Håkan Svedhem
Executive Editor
Geoscientific Instrumentation, Methods and Data Systems

I sincerely thank you for your suggestions. My answers to your questions are listed below.

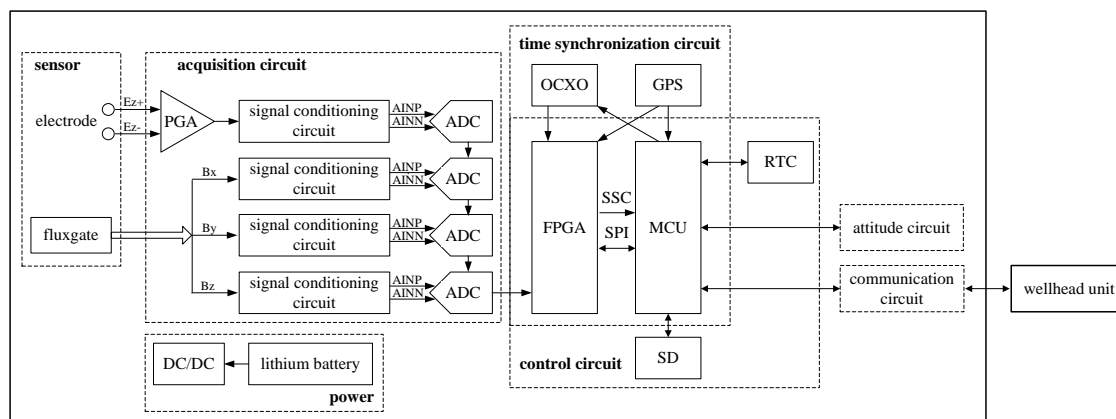
6. Paragraph 2.2 “... four analog-to-digital converters (ADCs) are daisy-chained”. In Fig. 3 it appears that the ADCs are individually connected to the FPGA (in parallel) and not daisy-chained. Please correct either text or drawing.

Response: As advised, we have revised Figure 3 to read as follows:
